# WA6659 GOOD SAMARITAN

LTE 1C RRH SWAP

PRCTI20240294

City of Puyallup  
Development  
Engineering  
APPROVED

SHEET  
**A-6.1**

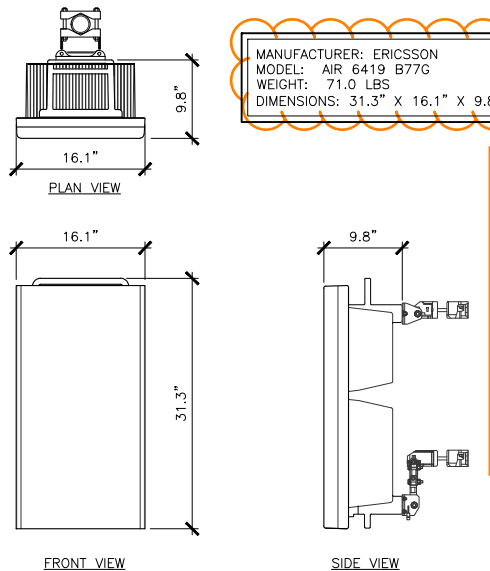
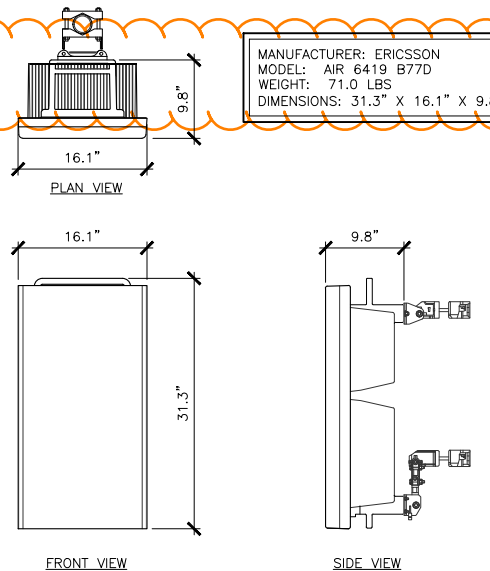
The weight of the AIR6419 B77G differs between the calculations (Structural Analysis, Mount Analysis, and Mount Design) and the specifications under details 1 and 2 on sheet A-6.1. Please confirm which weight is correct and make any necessary revisions. [1032 PLAN SET, sheet A6.1]

NETSURE -48VDC OUTDOOR BATTERY CABINET **2**

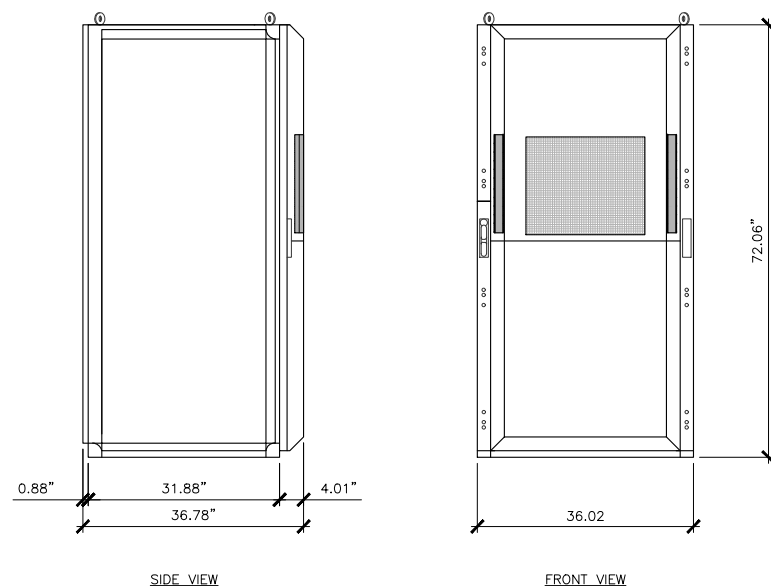
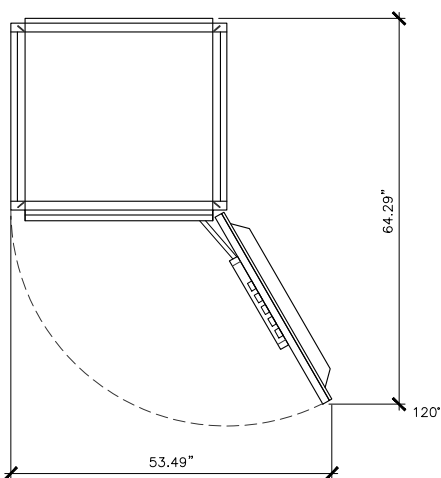
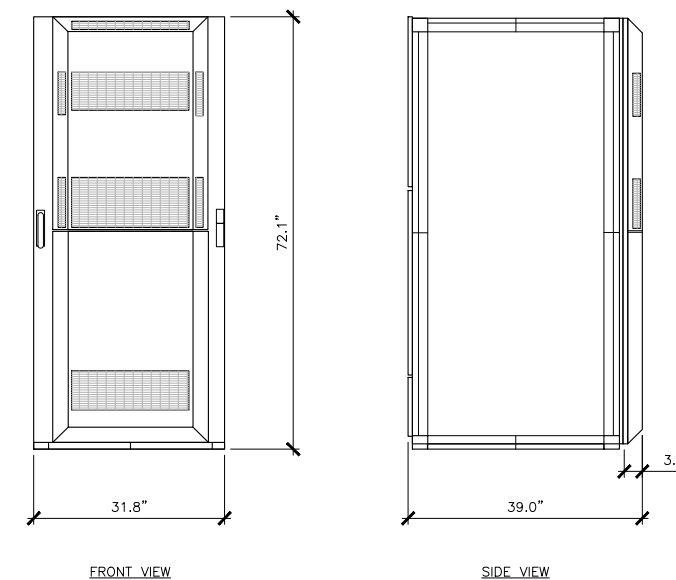
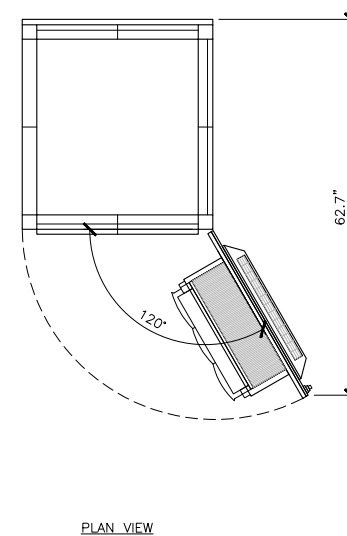
The weight of the Emerson Netsure Cabinet differs between the calculations (Structural Analysis, Mount Analysis, and Mount Design) and the specifications under detail 2 on sheet A-7. Please confirm which weight is correct and make any necessary revisions. [1032 PLAN SET, sheet A-7]
